## Monroe County Polling Location

**Bloomington High School South**  
**1965 S Walnut St**  
**Bloomington, IN 47401**  
**Accessibility Evaluation**  
**Inspection Date: 03/06/2026**  
**Inspectors: Chris Jackson**

**Report Date: 03/10/2026**

### **Finding: 1**

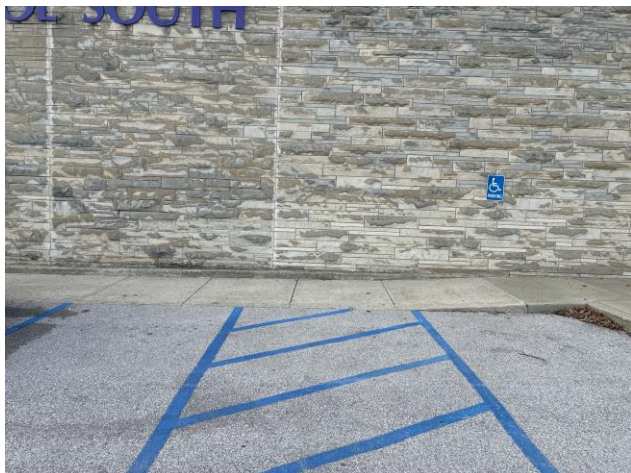
**Spaces South of Door:** The van space is missing the required van identification sign.

**Parking space identification signs shall include the International Symbol of Accessibility. Signs identifying van parking spaces shall contain the designation "van accessible."**

*2010 ADAS Section 502.6*

**Add temporary or permanent accessible parking signage to the space without signage. Add temporary or permanent "van accessible" signage to at least one of the four accessible spaces.**

### Finding: 3

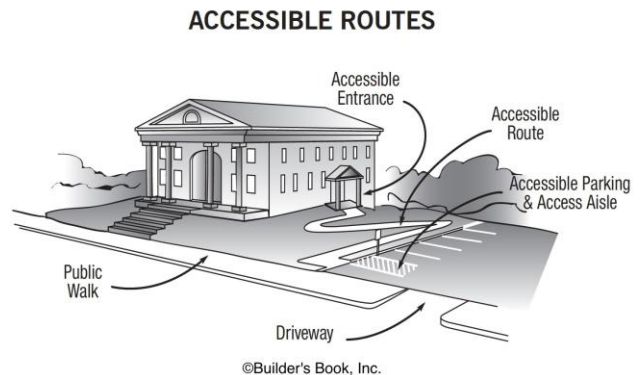
The access aisle is not located on an accessible route of travel to the accessible building entrance.

Accessible parking spaces serving a particular building shall be located on the shortest accessible route of travel from parking to an accessible entrance. In buildings with multiple accessible entrances with adjacent parking, accessible parking spaces shall be dispersed and located closest to the accessible entrances.

#### 2010 ADAS Section 208.3.1

Add cones to create a 36" wide protected path of travel along the sidewalk by the curb cut. This will also prevent vehicles from parking in front of the curb cut, even temporarily. (See additional photograph on next page for example cone placement.)
